Access Compliance Report

Public Rights-of-Way

| Intersection ID: 27865 | Main Street: ALEXANDER_MILL_DR | Cross Street: MCCOMB_MANOR_CT | Location: SW |
| ADA ID: 909EE8370F5C | Ramp Type: Perp | Initial Pass/Fail: Fail | Overall Compliance: No |

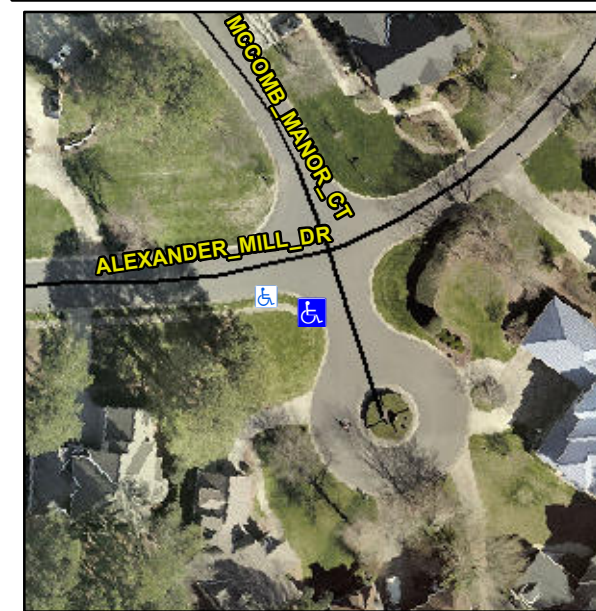
Not Found, R304.2.2, R304.5.3

| Compliance | Description | Data | Compliance | Description | Data |
|------------|-----------------------|------|------------|-----------------------------|------|
| N/A | Ramp Length (in) | 38.0 | No | Ramp Slope (%) | 9.3 |
| Yes | Ramp Width (in) | 48.0 | No | Ramp XSlope (%) | 7.6 |

Remove & Replace Entire Ramp.
